UNITED STATES
NUCLEAR REGULATORY COMMISSION

SUBJECT SUMMARY OF APRIL 25, 2000, MEETING WITH THE BOILING WATER
REACTOR OWNERS GROUP (BWROG) REGARDING APPENDIX R
SAFE SHUTDOWN

SUBJECT: BOILING WATER REACTOR OWNERS' GROUP (BWROG)
APPENDIX R FIRE PROTECTION COMMITTEE POSITION ON
SAFETY RELIEF VALVES (SRVs) AND LOW-PRESSURE SYSTEMS
(LPS) USED AS "REDUNDANT" SHUTDOWN SYSTEMS UNDER
APPENDIX R (TAC NO. MA4745)

FIGURE 1A: SMALL FIRE WITH PROTECTION

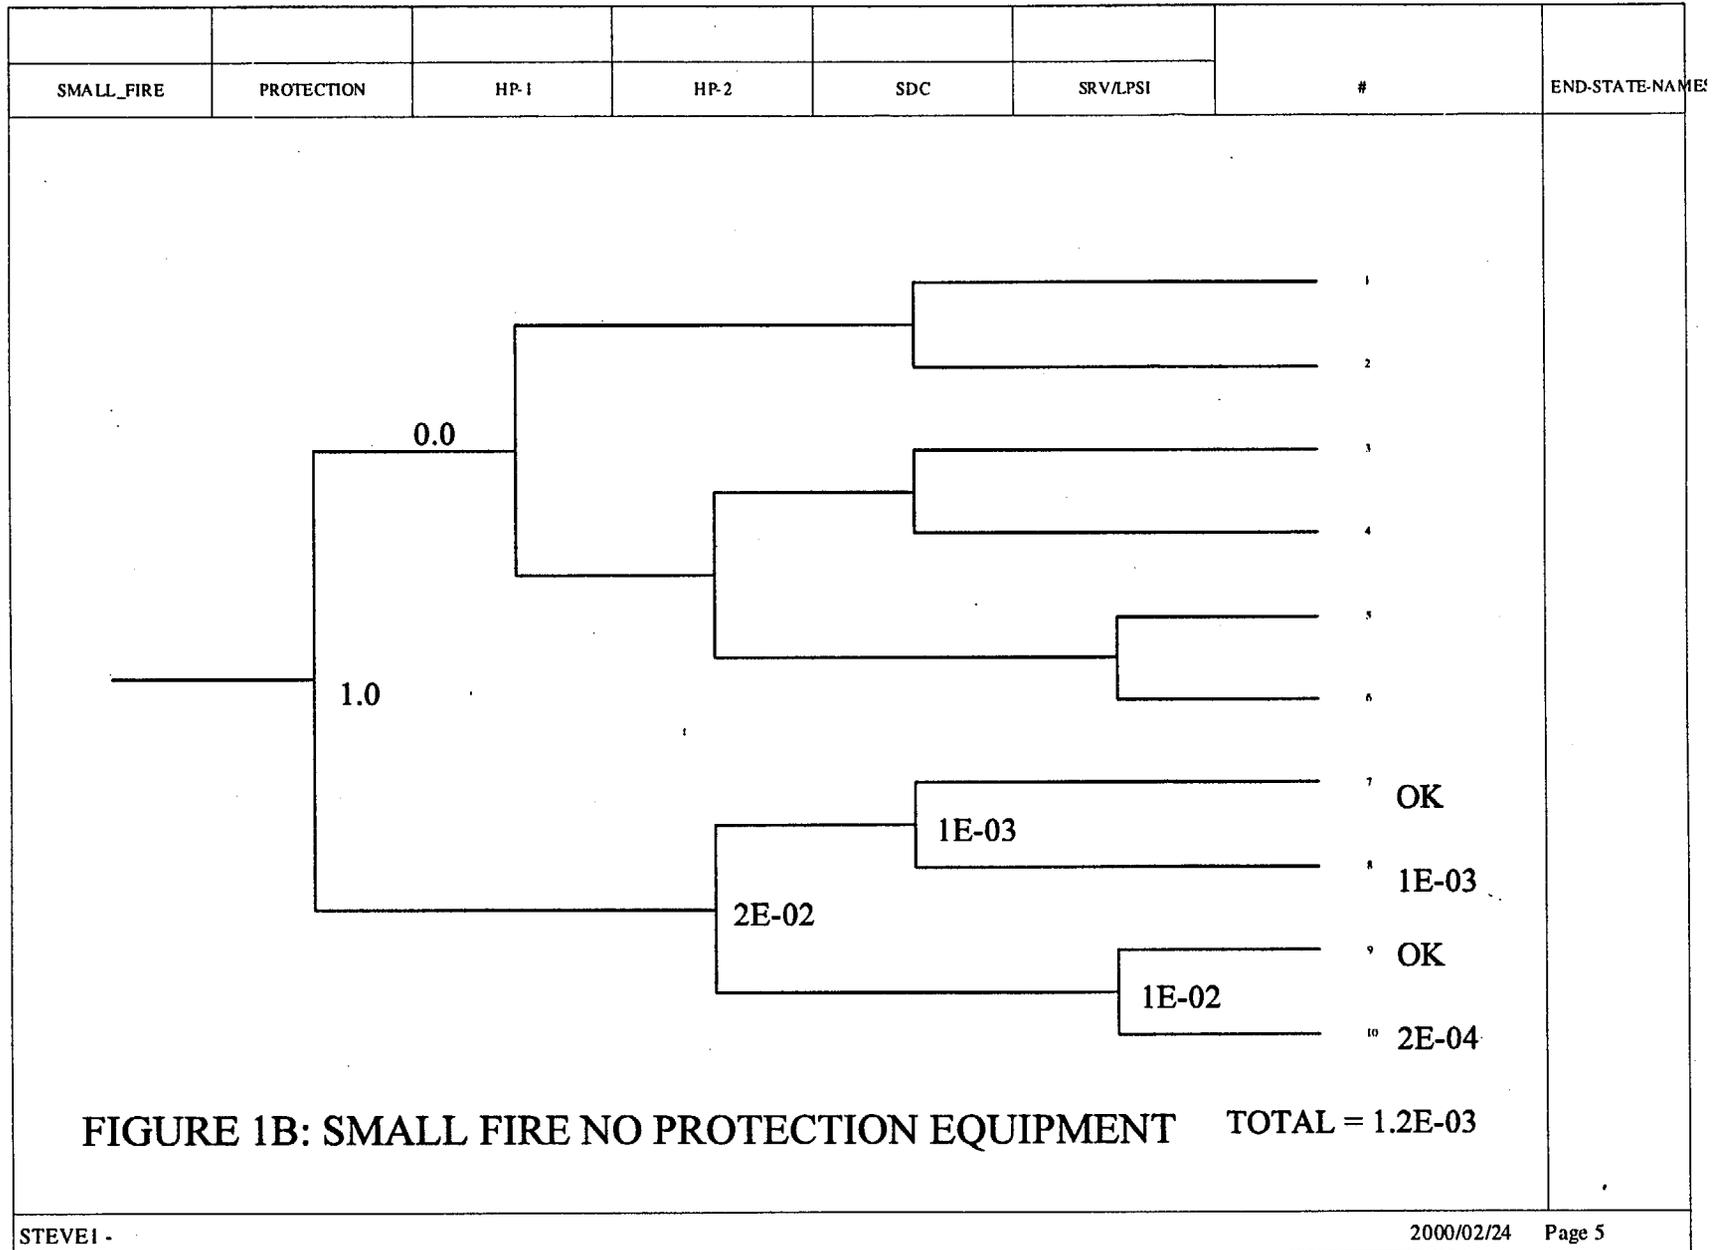
All calculations are done assuming a fire in a given area. That is, the estimates are core damage probability conditional on a fire in a given area. As illustrated by the figures, the following results are obtained

Small fire loads <i>with</i> fire protection in place:	1.0E-3 core damage probability given a fire
Small fire loads with fire protection removed:	1.2E-3 core damage probability given a fire
Large fire loads with fire protection in place:	1.7E-3 core damage probability given a fire
Large fire loads with fire protection removed:	1.0E-2 core damage probability given a fire

FIGURE 2B: LARGE FIRE WITH NO FIRE PROTECTION

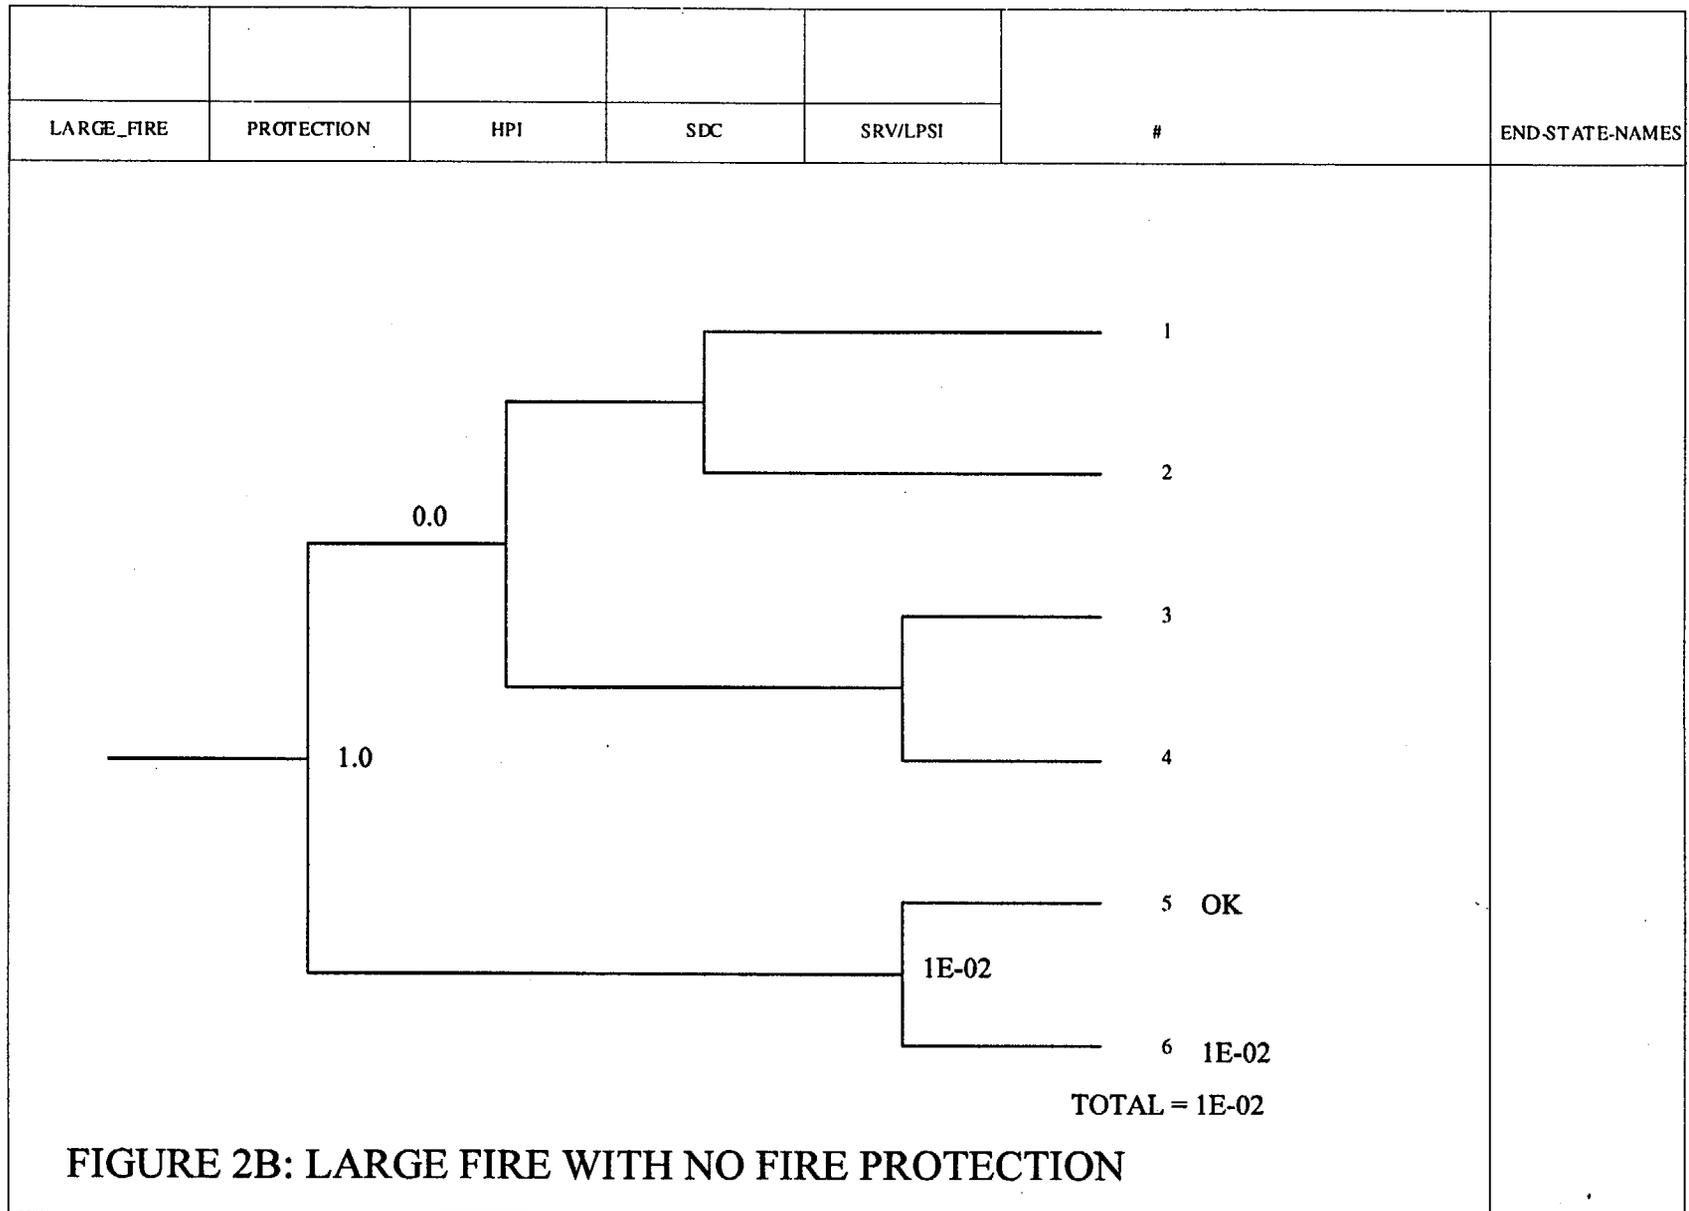
This indicates that removing the fire protection from areas with small fire loads has a negligible impact on the conditional core damage probability. Removing fire protection from areas with large fire loads may increase the conditional core damage probability by a factor of ten. Because the frequency of fire initiation is not affected by the fire protection features, the CDFs for each area would increase by the same factors.
